Subject: UNUSUAL NOISE FROM MANUAL TRANSMISSION WHEN DRIVING IN 2ND AND/OR 3RD GEAR	Bulletin No: 05-007/16
	Last Issued: 10/28/2016

2016-17 MX-5 vehicles with VINs lower than JM1ND*****102648 (produced before September 6, 2016)

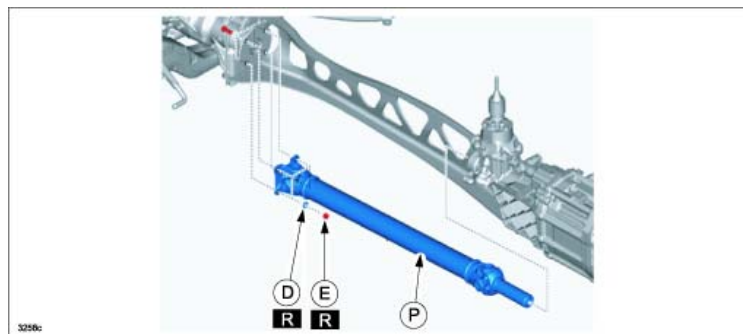
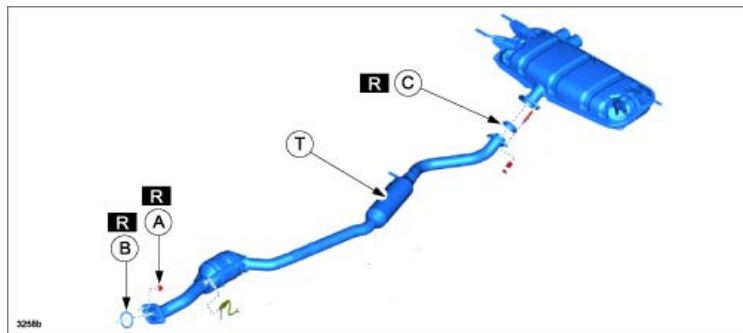
This may be caused by damage to 2nd and/or 3rd gears if the vehicle was driven with rapid acceleration and deceleration using frequent shift changes. To eliminate this concern, the configuration of the 2nd and 3rd gears has been changed to increase the rigidity.

NOTE: Transmissions with the serial No. "6TJ0900496" or higher are modified.

1. Verify the customer concern
2. Replace the complete manual transmission with a modified one according to the instructions on MS3 (TRANSMISSION REMOVAL/INSTALLATION [M66M-D]).
3. Verify the repair
